Amendments to the Drawings:

REMARKS/ARGUMENTS

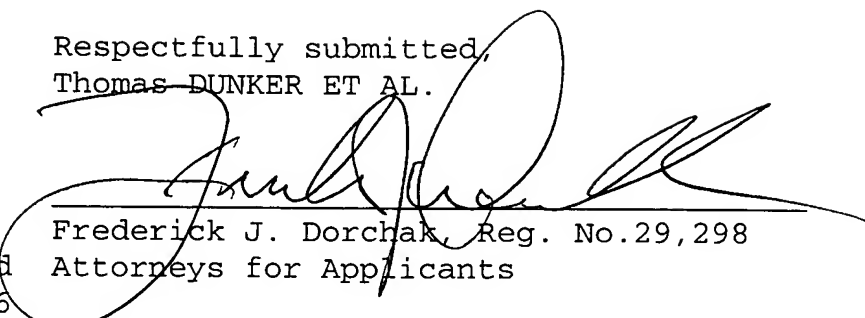
The attached sheet of drawings includes a change to FIG. 1b. In amended FIG. 1b, bending direction "A" as recited in claim 1 has been shown. This sheet, which depicts FIG. 1b, replaces the sheet currently on file depicting FIG. 1b.

The drawings were objected to under 37 CFR 1.83(a) as failing to show "a bending direction" as recited in claim 1. In response, Applicants have amended FIG. 1b to show bending direction "A", which it is respectfully submitted overcomes the objection of the Examiner to the drawings on the basis of this informality.
